DOWNTOWN MAIN STREET RECONSTRUCTION TASK FORCE AGENDA

MEMO

TO: Downtown Main Street Construction Task Force Members
FROM: Andrew Beyer, P.E.
DATE: March 19, 2024
RE: Downtown Main Street Construction Task Force Meeting of March 27, 2024

Review and take possible action: Downtown Main Street bump out locations

Enclosed:
Plan sheets provided by WisDOT

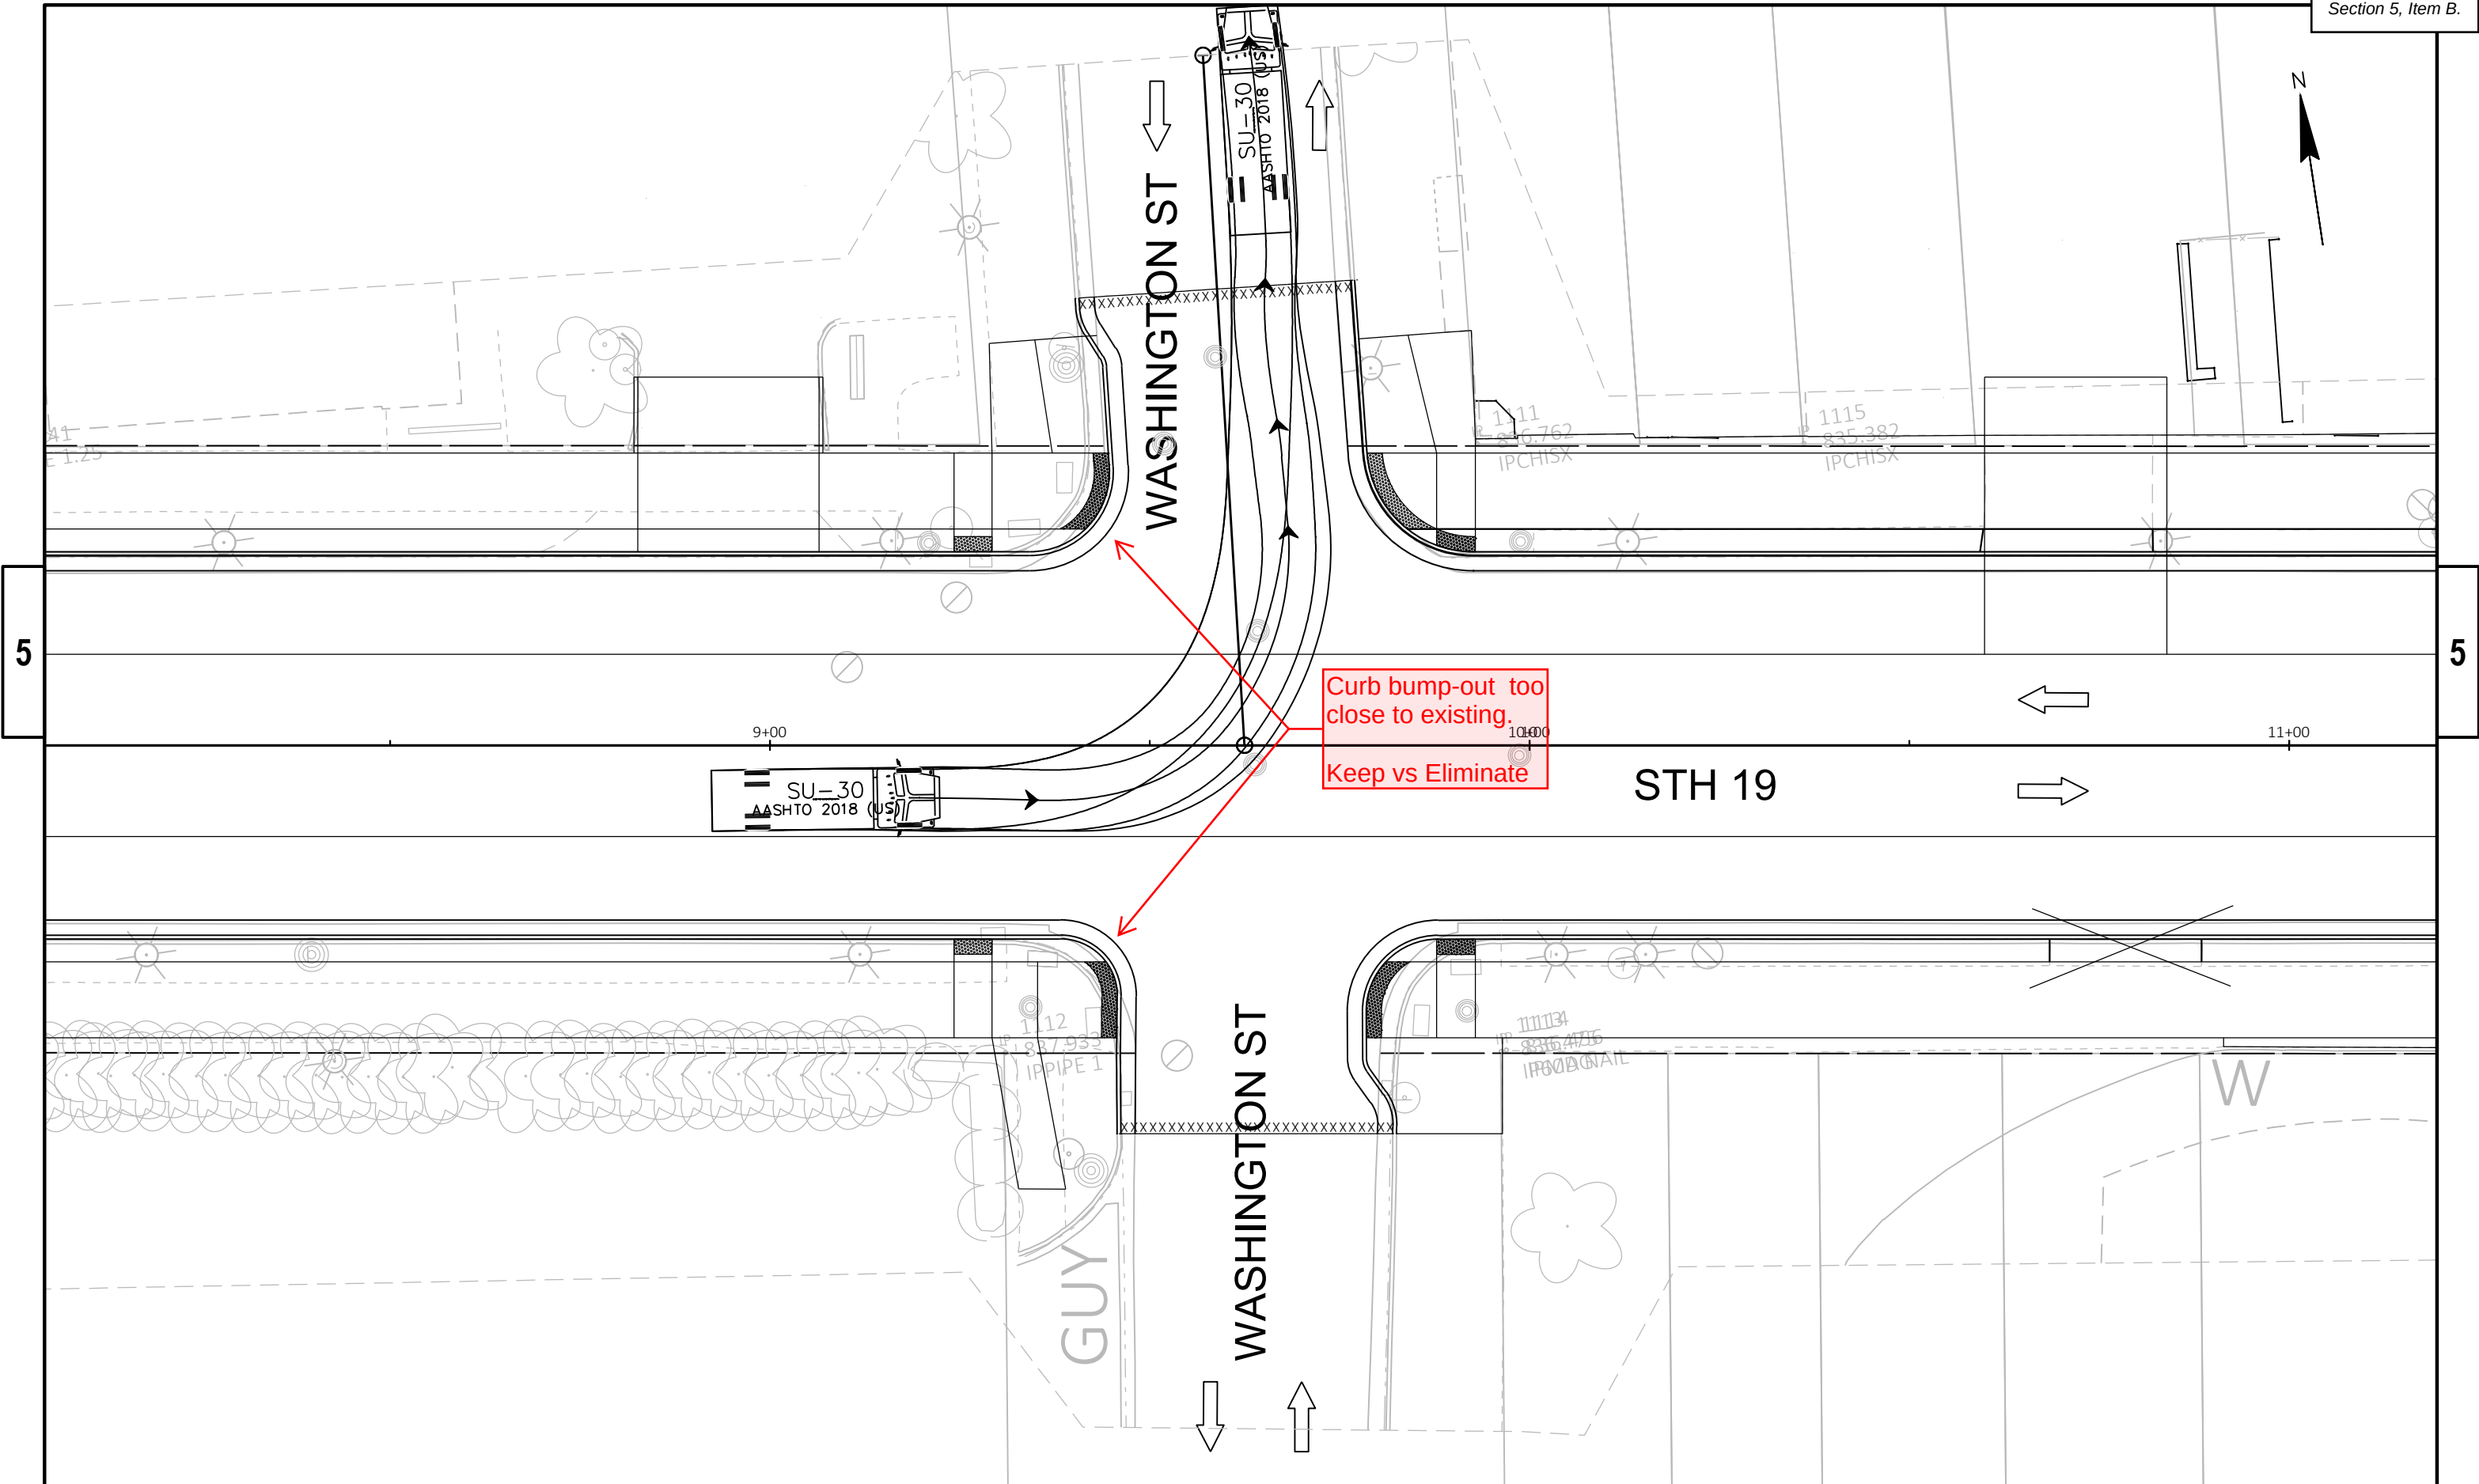
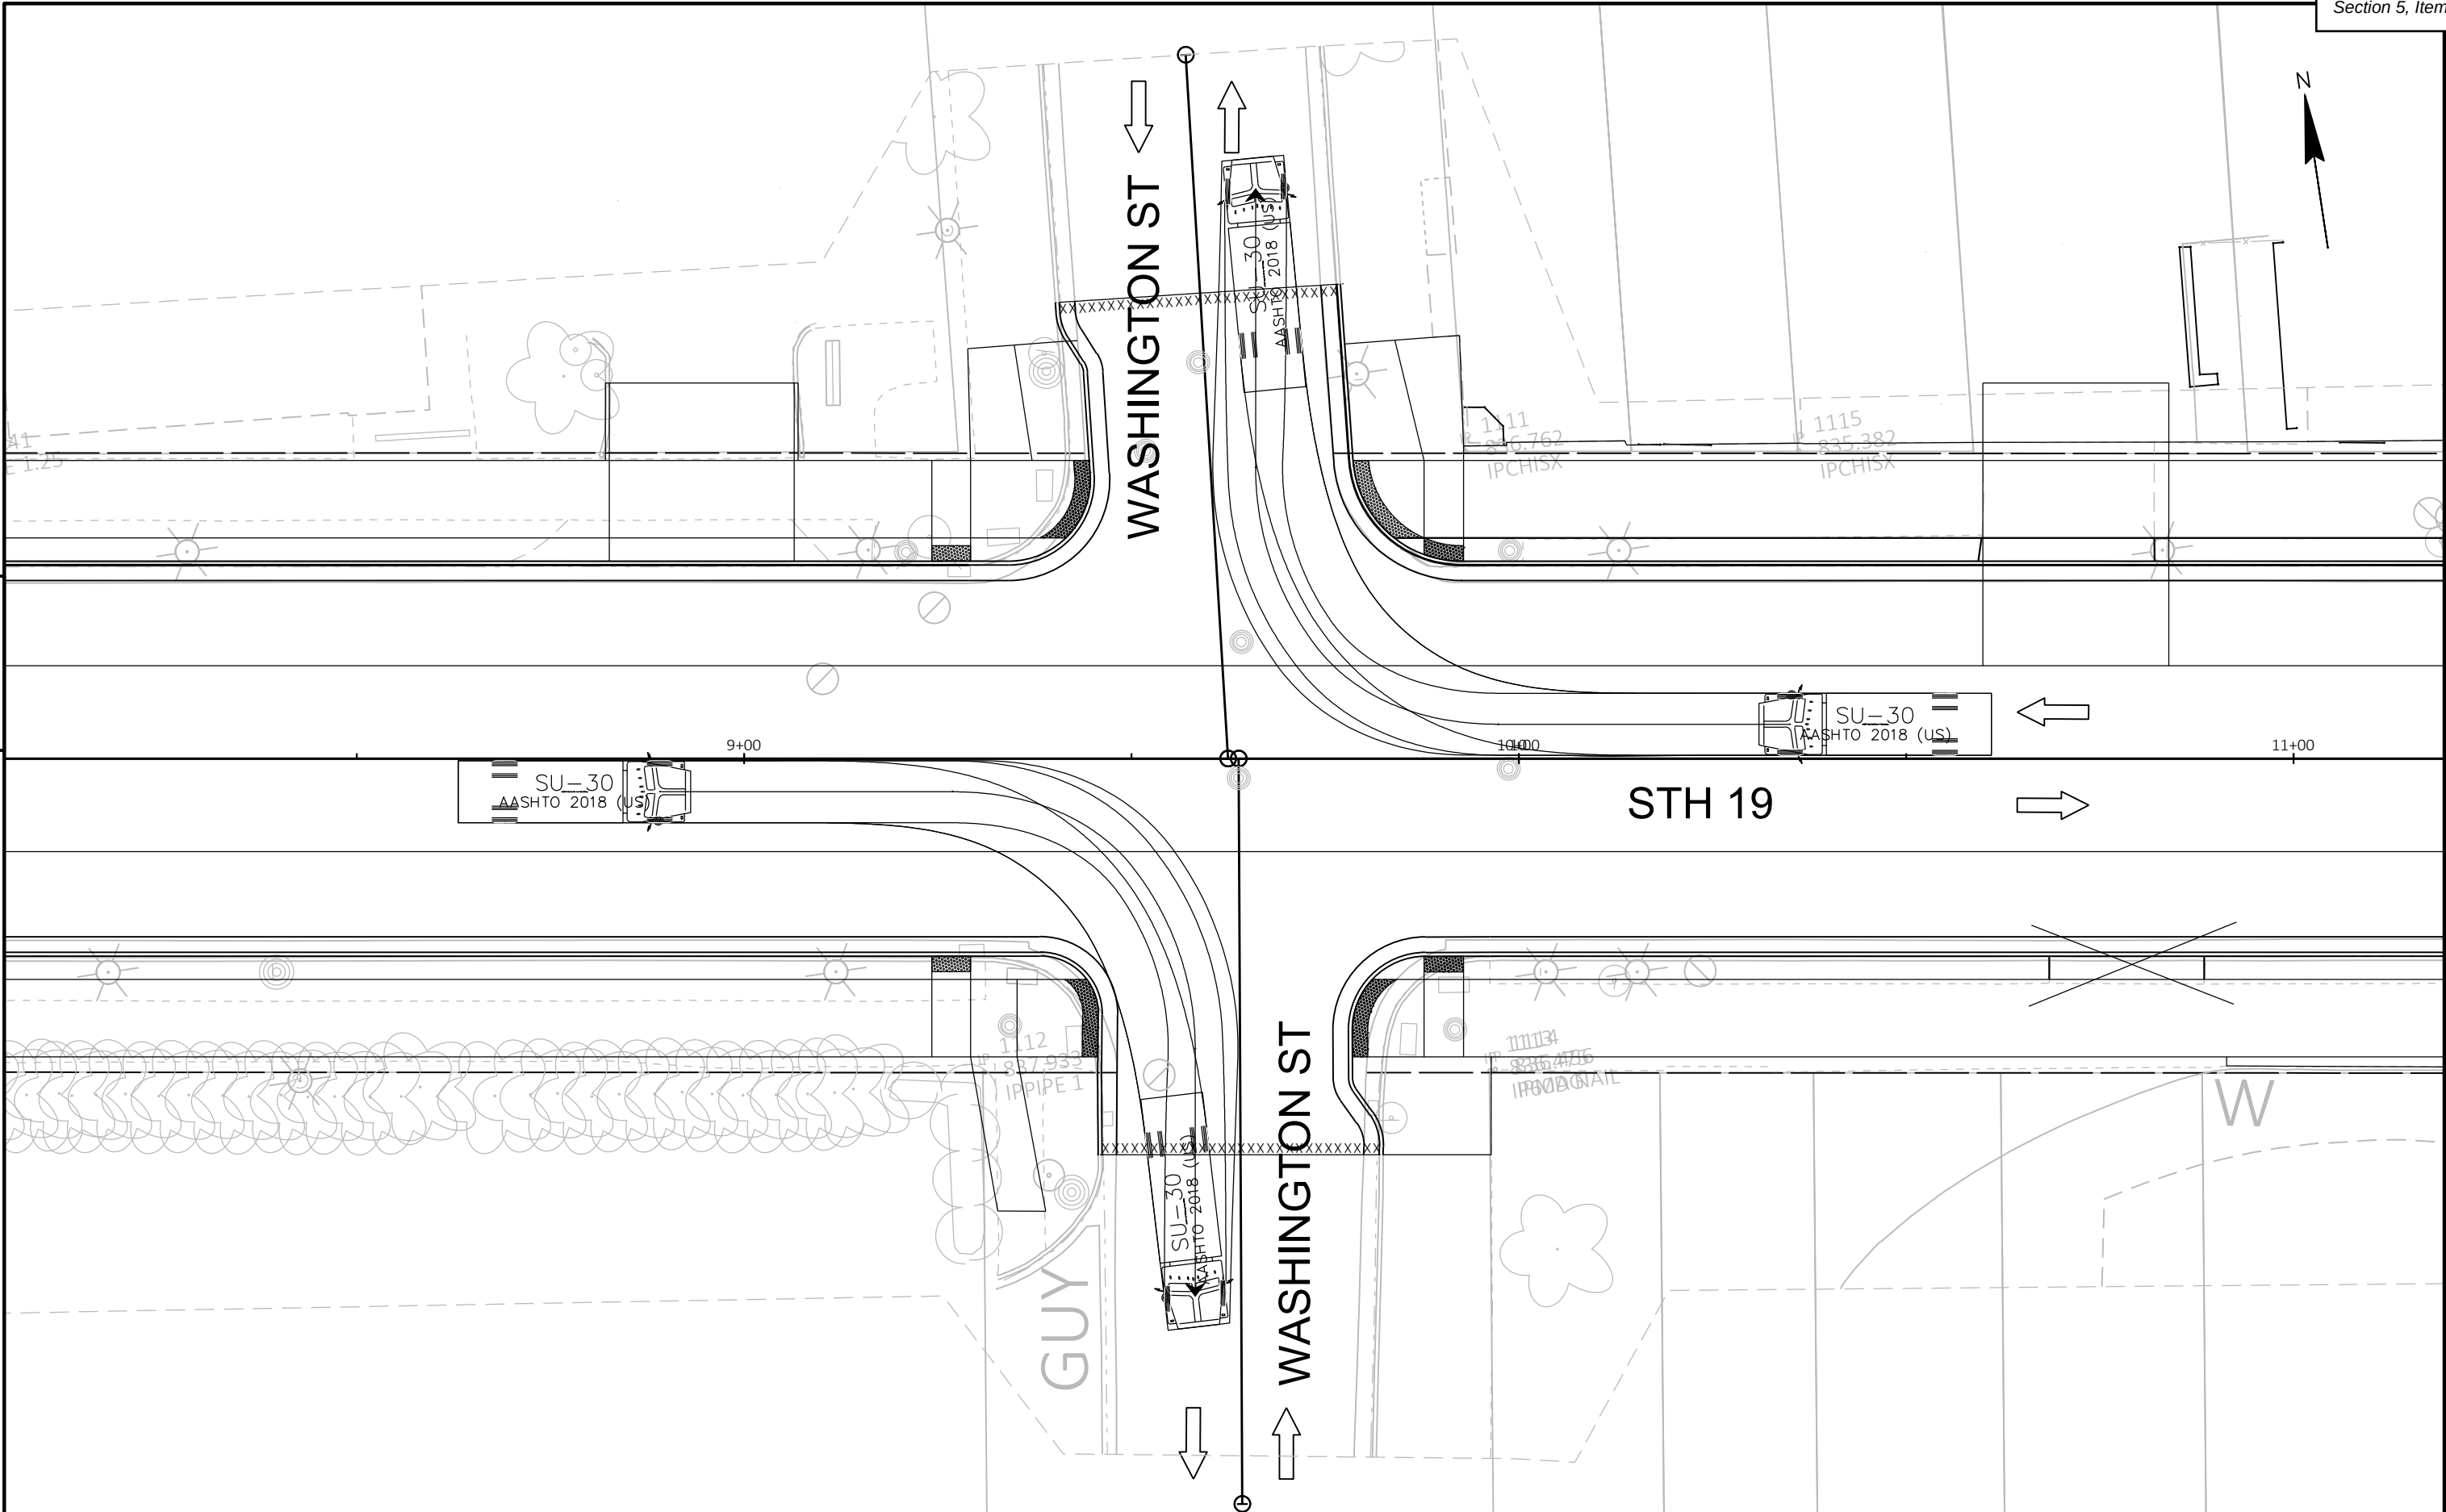
City of Watertown staff recently convened with Wisconsin Department of Transportation (WisDOT) representatives to assess proposed bump out locations for the Downtown Main Street Reconstruction Project spanning from Church Street to Market Street. The collaboration involved a detailed examination by the WisDOT design team of the bump out sizes and locations outlined in the Watertown Downtown Vision & Main Street Reconstruction Plan, particularly in regard to accommodating truck turning radii.

Following this review, it was determined that several bump outs identified in the plan require size reduction or elimination to ensure safe truck maneuvering onto and off of Main Street. Attached are plan sheets provided by the WisDOT design team, which illustrate the proposed changes for discussion.

WisDOT has solicited feedback from the City regarding the inclusion of smaller bump outs, e.g. on N. Fifth Street, or the elimination of minor bump outs from the plans.

- State said that a few of the intersections bump outs were reduced to 1' to 2' and the City may want to consider eliminating them as well as there would not be much of a benefit.

- State to provide markup identifying these locations to the City.
 - City will review and make decision if these should be eliminated as well.
- Handicap parking spot by the kiosk or mid block bump out?
